Subject: MHI's Response to US-APWR DCD RAI No. 350-2675 REVISION 1

Reference: 1) "Request for Additional Information No. 350-2675 Revision 1, SRP Section: 05.02.03 - Reactor Coolant Pressure Boundary Materials, Application Section: DCD Tier 2, Section 5.2.3" dated May 04, 2009.

**US-APWR Design Certification
Mitsubishi Heavy Industries
Docket No. 52-021**

RAI NO.: NO. 350-2675 REVISION 1
SRP SECTION: 05.02.03 - REACTOR COOLANT PRESSURE BOUNDARY MATERIALS
APPLICATION SECTION: DCD TIER 2, SECTION 5.2.3
DATE OF RAI ISSUE: 5/04/2009

Fig.1 pH range at 25°C

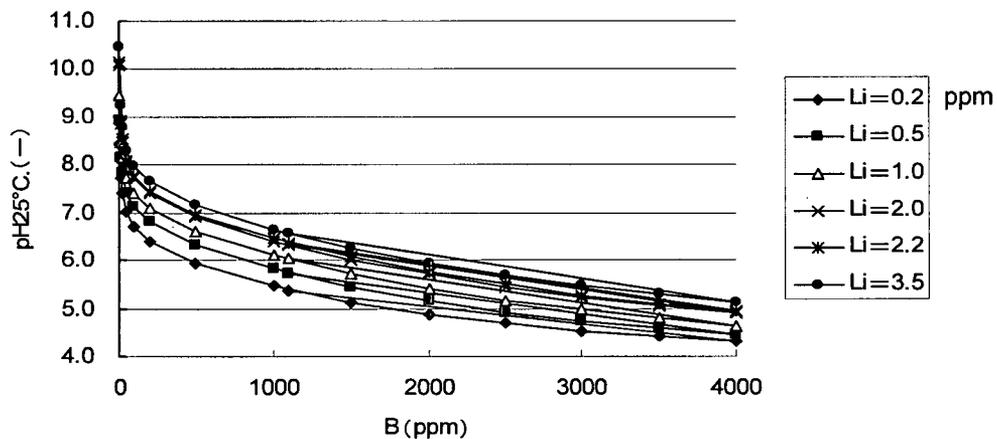
1. Clarify whether the pH limits given in Table 5.2.3-2 are intended to cover all operating modes (e.g., refueling, cold shutdown, startup, shutdown, and power operation), and when it would be necessary to allow a pH as high as 10.5? Is this a limit to prevent materials damage or representative of an actual plant operating condition?

Recommended pH range of Reactor Coolant Water Chemistry is described in Table-5.2.3-2 in the DCD. These values are pH at 25°C water chemistry condition.

Basically, pH of Reactor Coolant Water Chemistry is determined by boric acid and lithium concentration. Value of pH 4.2 (at 25°C) corresponds to combination of boron concentration 4000ppm and Li concentration 0.2ppm. Furthermore, pH 10.5 (at 25°C) corresponds to combination of boron concentration almost 0ppm and Li concentration 3.5ppm.

Fig.3 Change of pH at 25°C

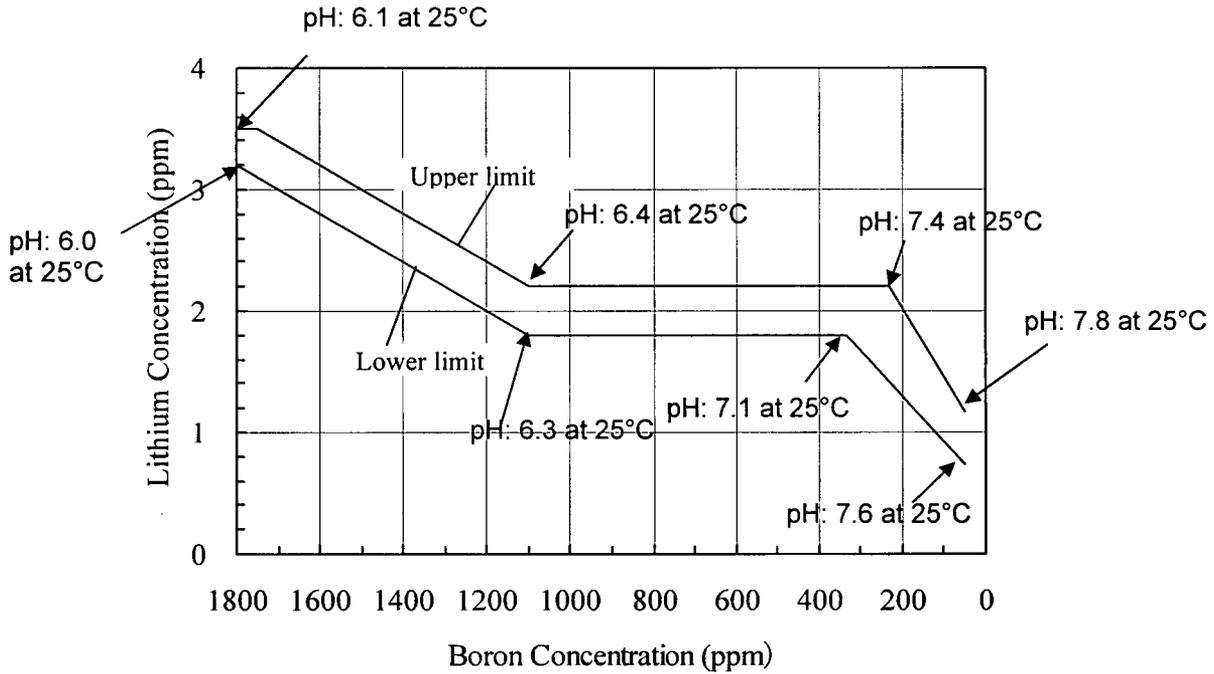
Additionally, in the RAI response, the applicant added temperature and pH labels to the upper- and lower-limit lines in Fig. 5.2.3-1. However, the explanation of pH control in the text is inconsistent with the figure. DCD Figure 5.2.3-1 resembles Figures 2-4 and A-2 of the EPRI PWR Primary Water Chemistry Guidelines, Rev. 6 (EPRI guidelines). The supporting discussion and the pH labels on Figure 5.2.3-1 leave the impression that the Upper Limit and Lower Limit curves (each consist of 3 connected segments) are curves of constant pH. This is not the case, as can be seen from EPRI Guidelines Figs. 2-2, 2-5, and Table A-3, where curves of constant pH are monotone decreasing. The middle region of constant lithium inventory (seen in both EPRI Guidelines Fig. 2-4 and DCD Fig. 5.2.3-1) is actually one of changing pH (increasing as boron decreases). (There is also such a flat region in EPRI Fig. 2-3.) The EPRI Guidelines describe different strategies of varying lithium and boron additions during startup and operation, and some of these strategies involve deliberate changes in pH over the course of operation (this is certainly

true of the "modified" approach represented by Fig. 2-4). The DCD describes a plan of maintaining constant pH within limits, and does not mention any change in the limits over an operating cycle. Thus, the DCD text is inconsistent with both DCD Figure 5.2.3-1 and Figure 2-4 of the EPRI Guidelines, which both depict a modified chemistry regime in which the pH changes during the course of the cycle. The staff desires that applicant provide more detail regarding their approach to pH control. Simply referencing the "EPRI Model" is inadequate, since the EPRI guidelines does not clearly define a model, and mentions several that are in use.

According to lithium control band during power operation in Figure-5.2.3-1 in the DCD, ranges of pH at 25°C (without impurity) are shown in Fig. 3. Value of pH is within 4.2 -10.5.

Fig.4 Change of pH at 300 and 285°C

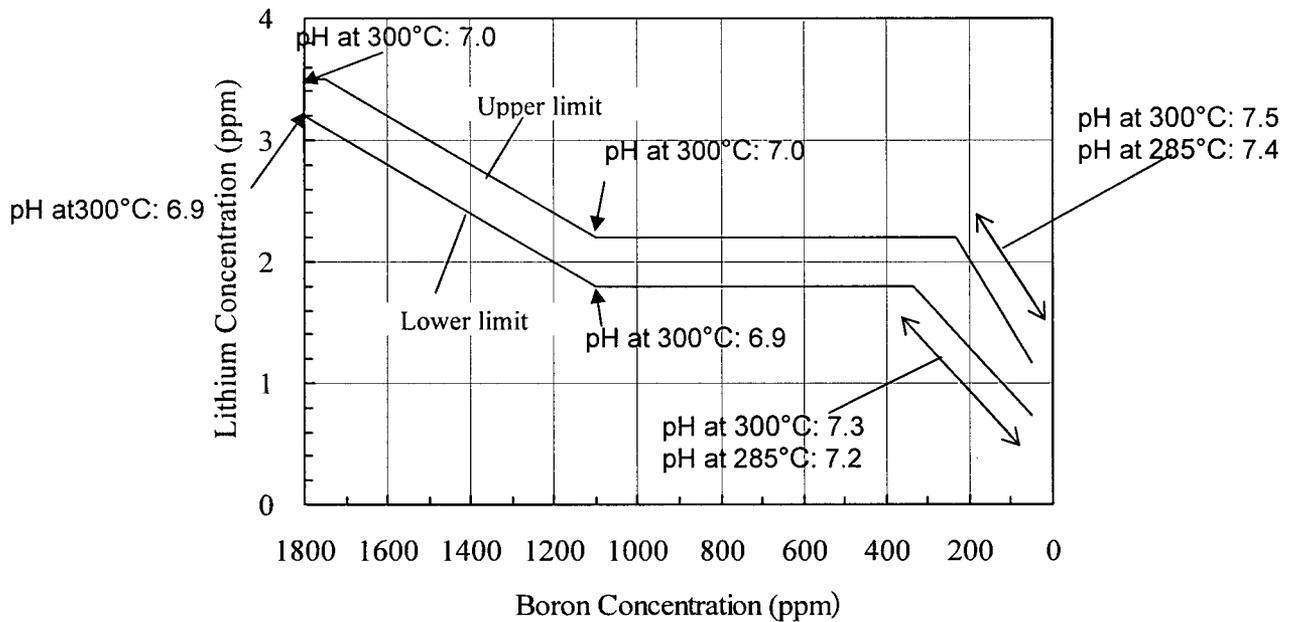
2. Describe the strategy for pH control for the entire operating cycles, including startup and full-power operation. Discuss any plans to vary pH over the course of the fuel cycle. Is the intent for the US-APWR to follow a modified chemistry regime as defined in the EPRI Guidelines?

Values of pH in several points are shown in Figure 4 below. In USA, high temperature pH is calculated under 300°C. Therefore, MHI calculates pH at 300°C. When boron concentration decreases from 1800 to 1100 ppm, pH is kept constant around 7.0. When boron concentration decreases from 1100 to almost 300 ppm, pH increases. When boron concentration decreases from almost 300 to 50ppm, pH is kept around 7.4 ± 0.1 .

Optimum high pH value range at 300°C, shown in Fig. 4, is 6.9 to 7.5. In constant pH region where boron concentration less than 300ppm, pH value at 285°C is kept 7.3 ± 0.1 . These values are consistent with DCD chapter 9.

MHI will revise Figure-5.2.3-1 in the DCD like Fig.4.
